East Port Water Reclamation Facility Expansion

CCU Change Order Request
East Port WRF Expansion - CCU File # 18-0006
Change Order 2

Project Name:	East Port WRF Expansion	Date:	11/19/2024
Owner:	Charlotte County Utilities	CCU No:	18-0006
Engineering Consultant:	Jones Edmunds	PO No:	2024000830
Prime Contractor:	Pool and Kent		
Contract No:	23-485		
Utility PM/EDM/ECM:	Hendrik Dolleman		
Change Order No:

PROPOSED CONTRACT MODIFICATION (PCM) No. 19

DWG NO. E37

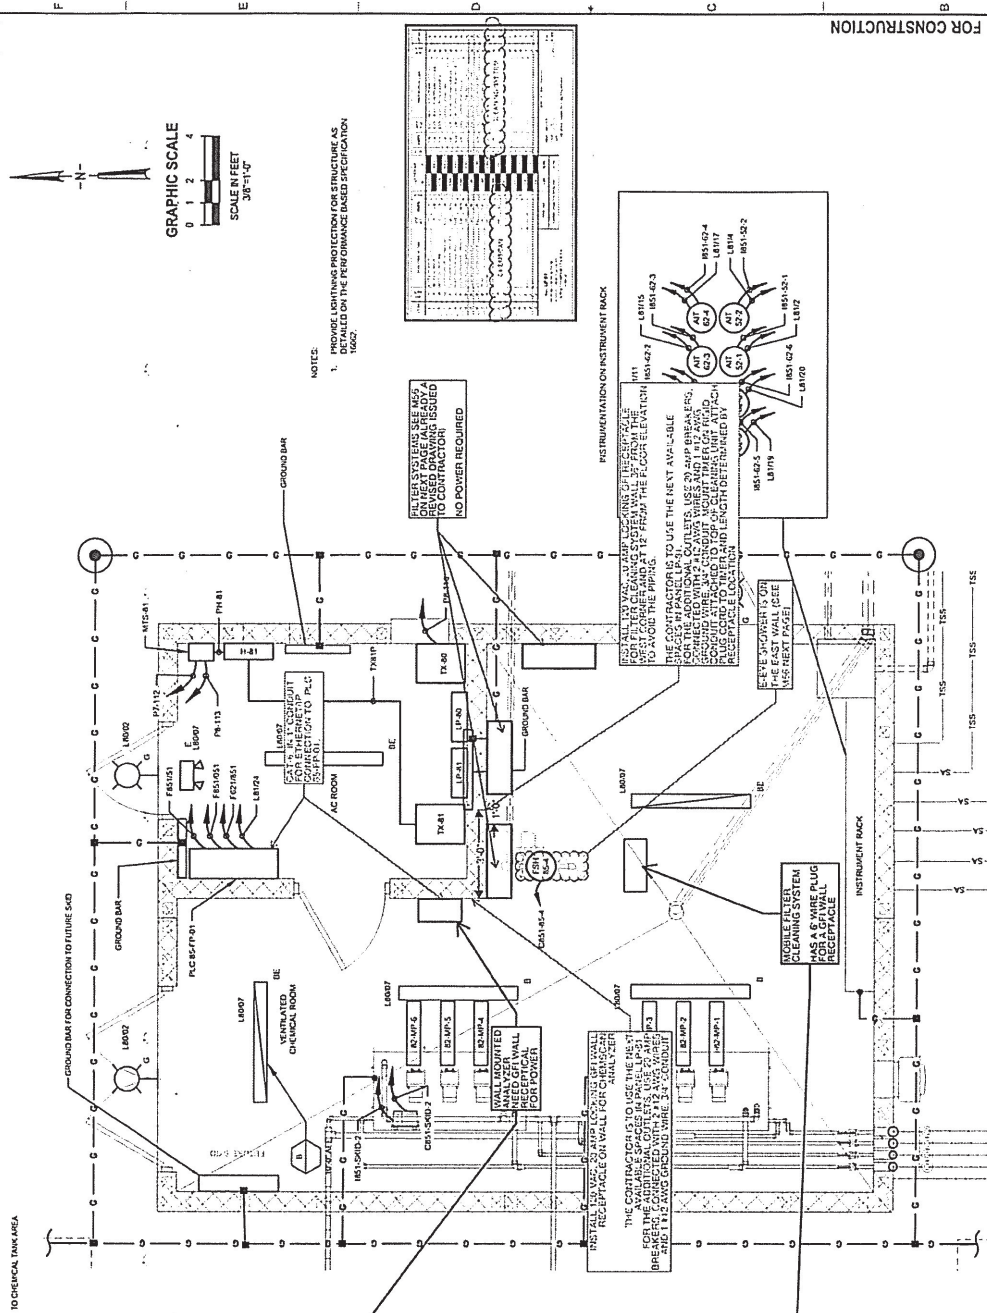
CONTRACT DOCUMENT REFERENCE(S): Attached sketch Sheet E37

Furnish and install (2) 120 Volt GFCI Receptacles from local panel indicated in the attached drawing.

REASON FOR MODIFICATION: Required power supply for Analyzer and Filter units.

PROJECT NO. 03405-012-09
DATE: JANUARY 2024
DWG NO. E37

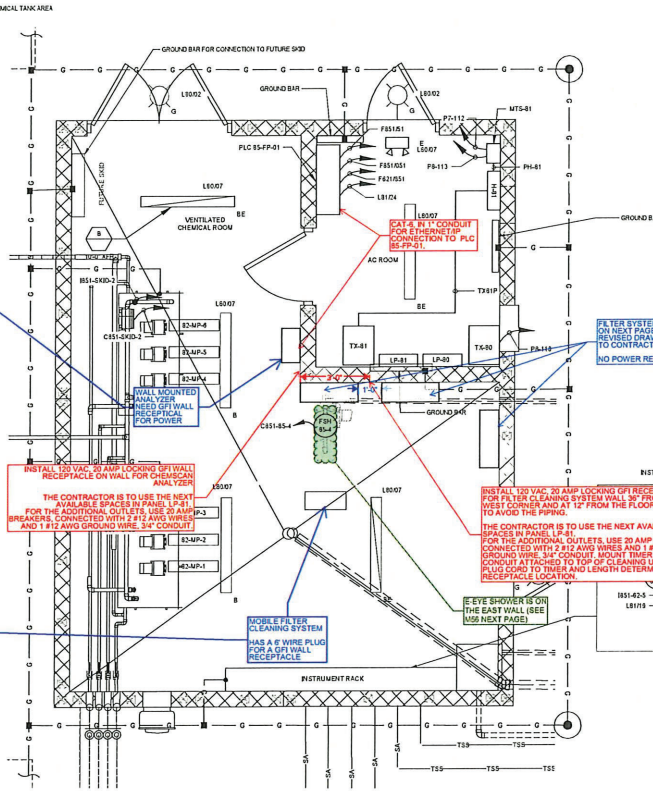
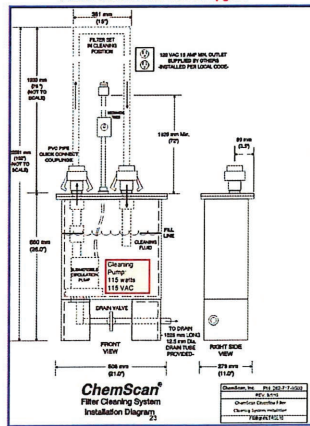
CONTRACT DOCUMENT REFERENCE(S): Attached sketch Sheet E37

Furnish and install (2) 120 Volt GFCI Receptacles from local panel indicated in the attached drawing.

REASON FOR MODIFICATION: Required power supply for Analyzer and Filter units.

NO.	DESCRIPTION	DATE
1	120 VAC, 20 AMP LOCKING GFI RECEPTACLE ON WALL FOR CHEMSCAN ANALYZER	1/12/2024
2	120 VAC, 20 AMP LOCKING GFI RECEPTACLE FOR FILTER CLEANING SYSTEM WALL 9' FROM THE WEST CORNER AND AT 12" FROM THE FLOOR ELEVATION TO AVOID THE PIPING	1/12/2024
3	120 VAC, 20 AMP LOCKING GFI RECEPTACLE ON WALL FOR CHEMSCAN ANALYZER	1/12/2024
4	120 VAC, 20 AMP LOCKING GFI RECEPTACLE FOR FILTER CLEANING SYSTEM WALL 9' FROM THE WEST CORNER AND AT 12" FROM THE FLOOR ELEVATION TO AVOID THE PIPING	1/12/2024

PROJECT NO.
03405-012-09
DATE
JANUARY 2024
DWG NO.
M56

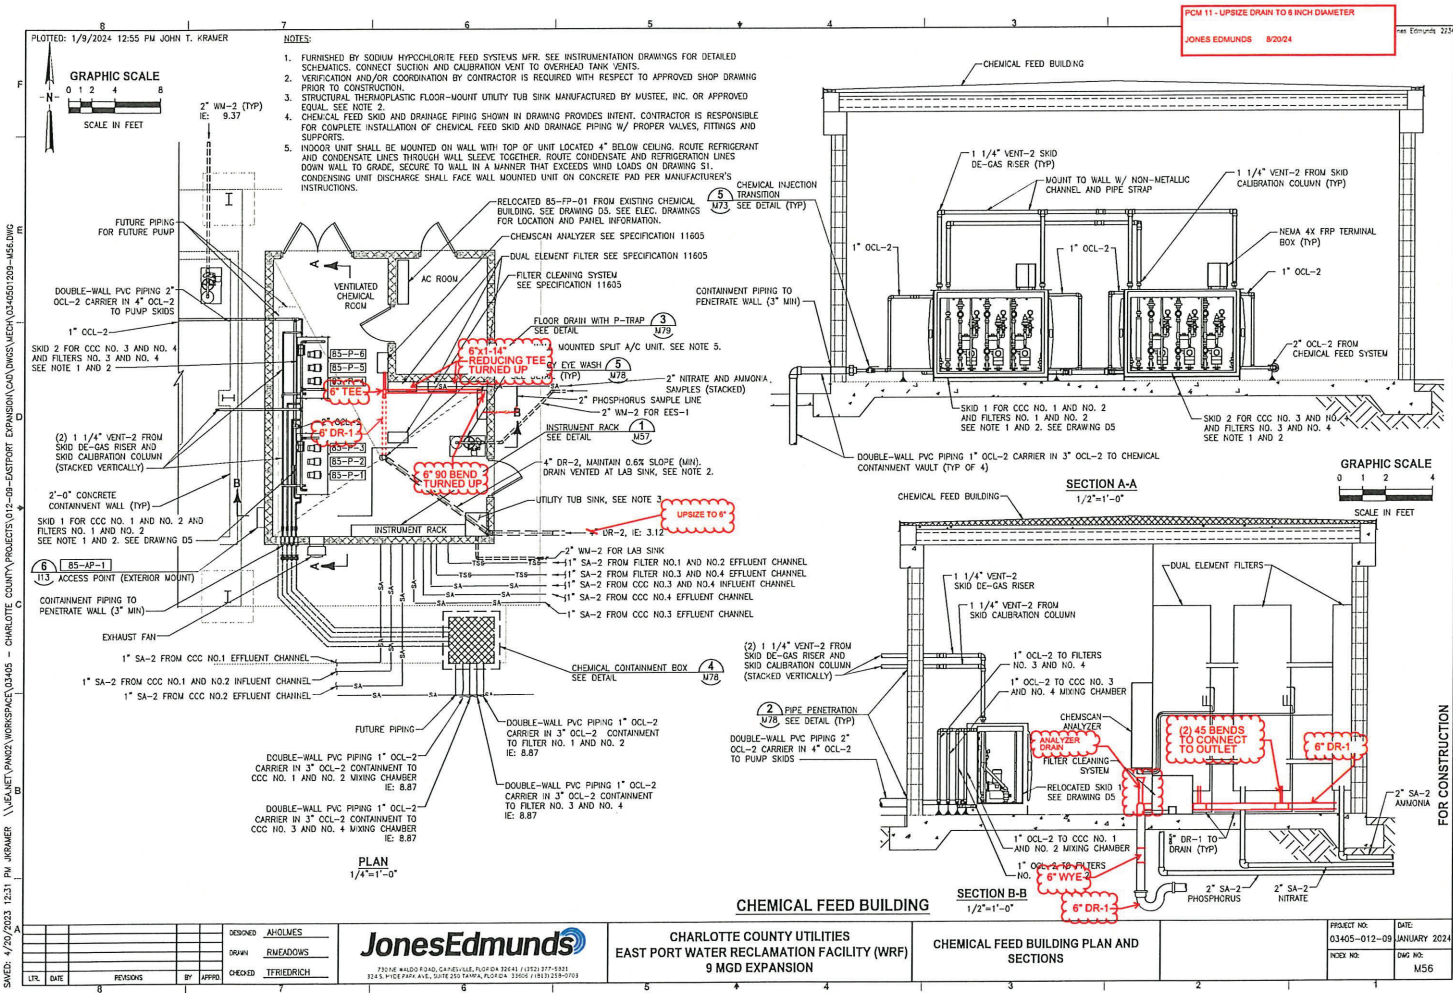
CONTRACT DOCUMENT REFERENCE(S): Revised Markup of Drawing Sheet M-56

1. Upsize drainpipe diameter to 6-Inch as shown per attached Sheet M-56 in the Chemical Feed Building.

REASON FOR MODIFICATION: To accommodate submitted Analyzer process stream.
